No. TCD-8201C-2016

Date of Issue: June 3, 2016

Japan Civil Aviation Bureau
TAIKUSEI-KAIZEN-TSUHO
Airworthiness Directive

1. Applies to: Kawasaki BK117 series helicopters equipped with a Goodrich rescue hoist assembly having a Part Number (P/N) as listed in Table 2.1 of this AD.

Figure 1

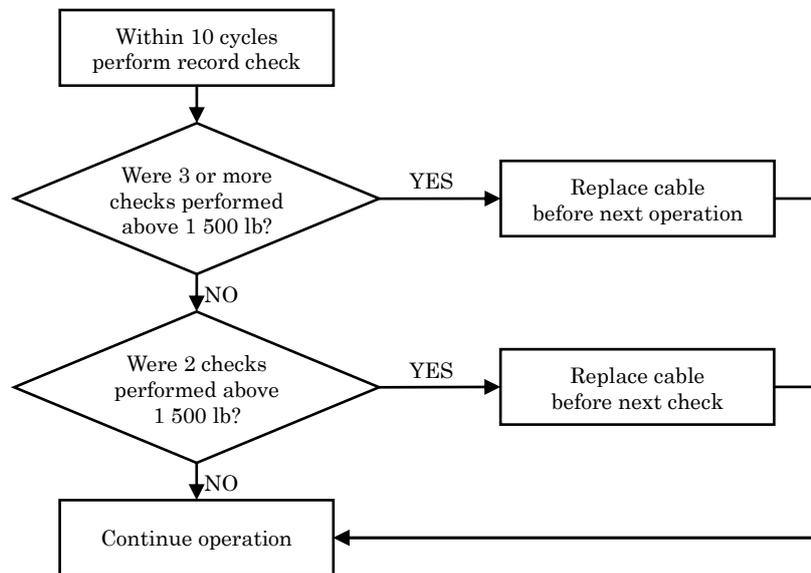
2.1 Within 10 hoist operating cycles after the effective date of this AD, accomplish a records check to determine whether, during any previous hoist load check/test, a cable was load-tested (average of 5 pulls) at 1 500 lb [680 kg] or more. If any cable is identified to have exceeded this limit during two or more hoist load checks/tests, replace the affected cable with a serviceable cable within the time interval shown in paragraph 2.1.1 or 2.1.2 of this AD. For replacement of a cable, see figure 1 of this AD.

2.1.1 If any cable is identified to have exceeded this limit during three or more hoist load checks/tests, before next hoist operation, replace the affected cable with a serviceable cable.

2.1.2 If any cable is identified to have exceeded this limit during two hoist load checks/tests, before the next hoist load check/test, replace the affected cable with a serviceable cable.
